Memorandum

Department of Planning

RE: **P.Z. 04-2021 Wings Corporate Estates, Lots 14 & 16 (Stock and Associates)**: A request for a zoning map amendment from the 'PI' Planned Industrial District to a new 'PI' Planned Industrial District for a 3.083-acre tract of land located at the southwest corner of the intersection of Wings Corporate Drive and Buzz Westfall Drive (18W440122, 18W440133).

Planning Commission Staff Report

PRELIMINARY DEVELOPMENT PLAN

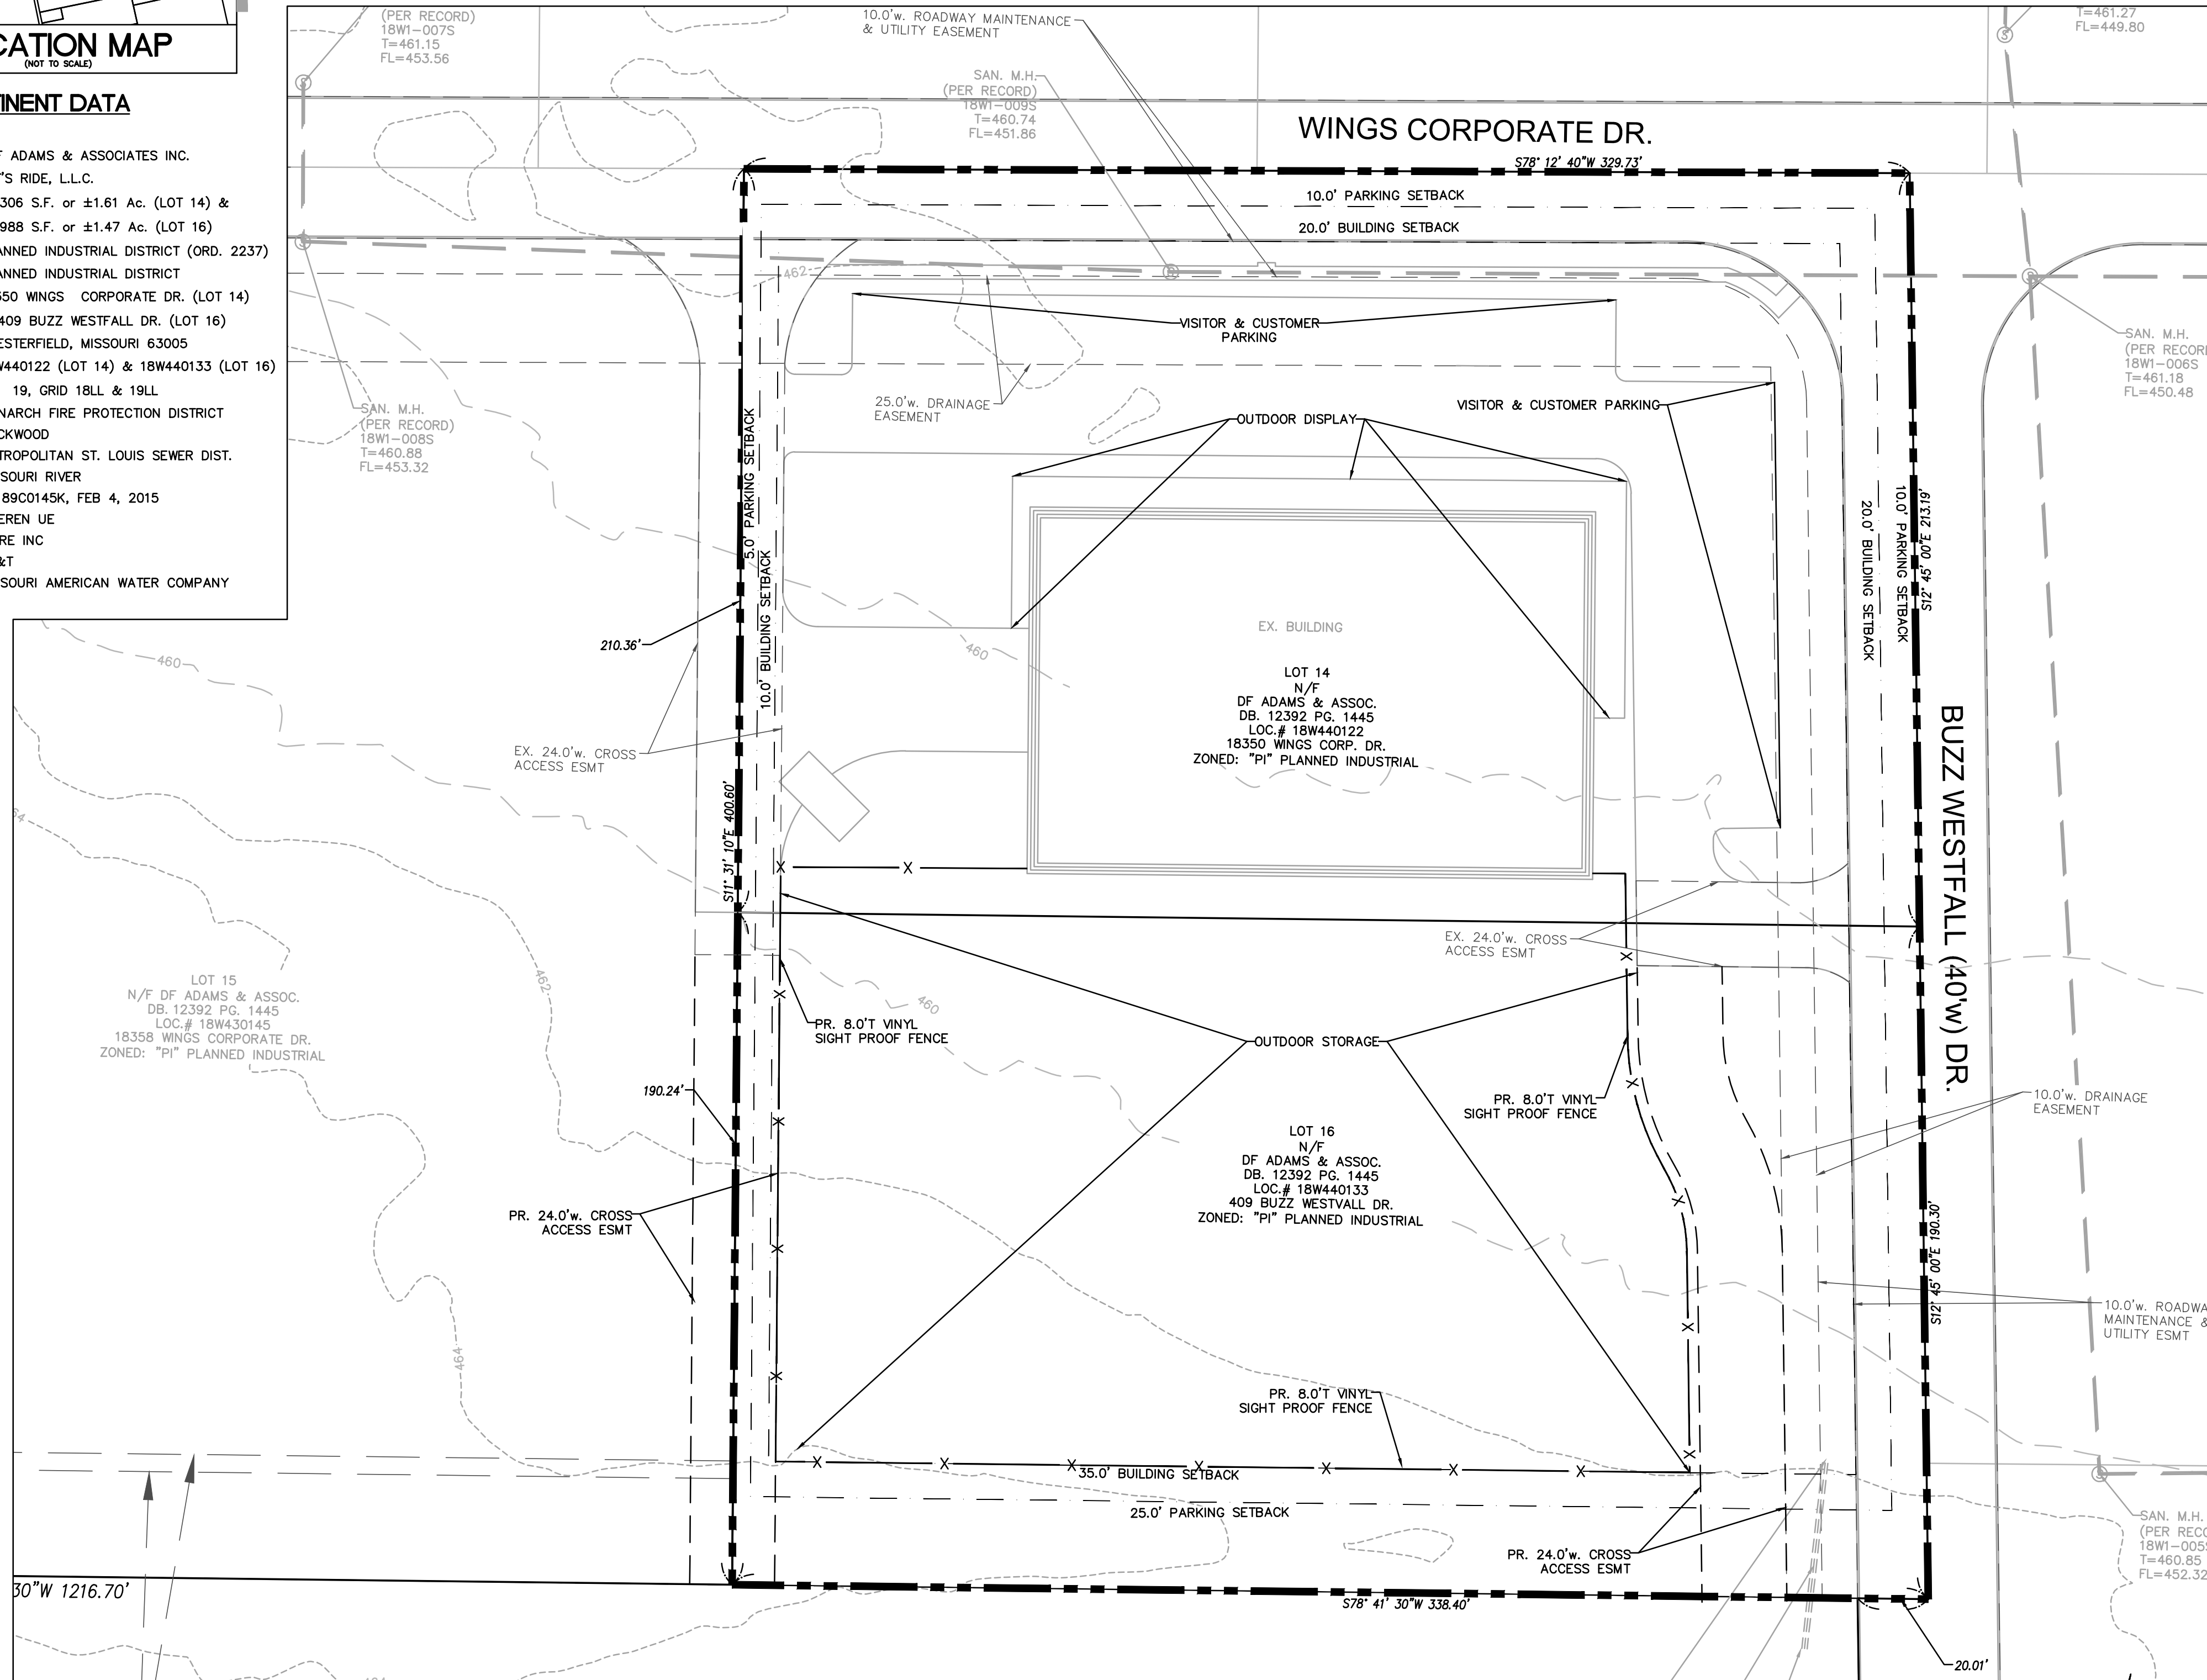
Issue: Planning Commission stated that the open space for this district align with the UDC requirement for “PI” —Planned Industrial District of 35% as opposed to 30% as requested by the applicant.

Issue: Substantial discussion was held by Planning Commission regarding how crates in the outdoor storage area were to be screened. The applicant mentioned that crates could be stacked up to four-high, or roughly twenty feet (20’). Planning Commission expressed concern as to how this will be fully screened from the site’s exterior and directed Staff to review screening requirements with the Applicant.

Applicant Response: The applicant has revised the project narrative and Preliminary Development Plan to reflect a 35% open space requirement.

Applicant Response: Applicant is amenable to Staff’s proposal that an eight-foot (8’) vinyl fence be located within structure setbacks to further screen these crates from view.

The request includes a Preliminary Development Plan that depicts the proposed outdoor storage area on Lot 16 for future expansion of the dealership use. This plan also depicts areas where vehicles would be placed on display during business hours around the north, east and west sides of the building. A survey has also been provided with the Preliminary Plan.
